# Access Compliance Report Public Rights-of-Way (Curb Ramps)

Main Street: BRADCLIFF\_DR Cross Street: COVENTRY\_PL Location: SW

ADA ID: RPRK211013110027 Ramp Type: Type 4 - Parallel Initial Pass/Fail: Fail Overall Compliance: No Severity Score: 32

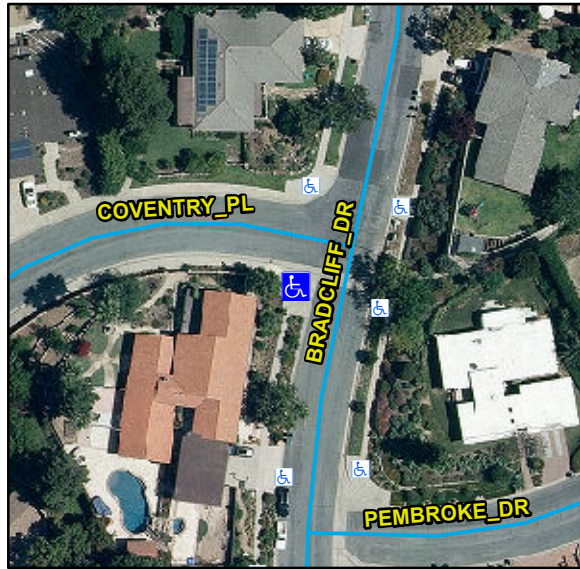
R304.3.2, R304.5.3, STD 1115

| Compliance | Description                   | Data       | Compliance | Description                   | Data |
|------------|-------------------------------|------------|------------|-------------------------------|------|
| No         | Ramp Run Slope LT (%)         | 13         | Yes        | Ramp Run Slope RT (%)         | 0.5  |
| No         | Ramp Cross Slope LT (%)       | 4.6        | No         | Ramp Cross Slope RT (%)       | 4.8  |

Remove & Replace Curb Ramp With Two New Directional Ramps or Equivalent.
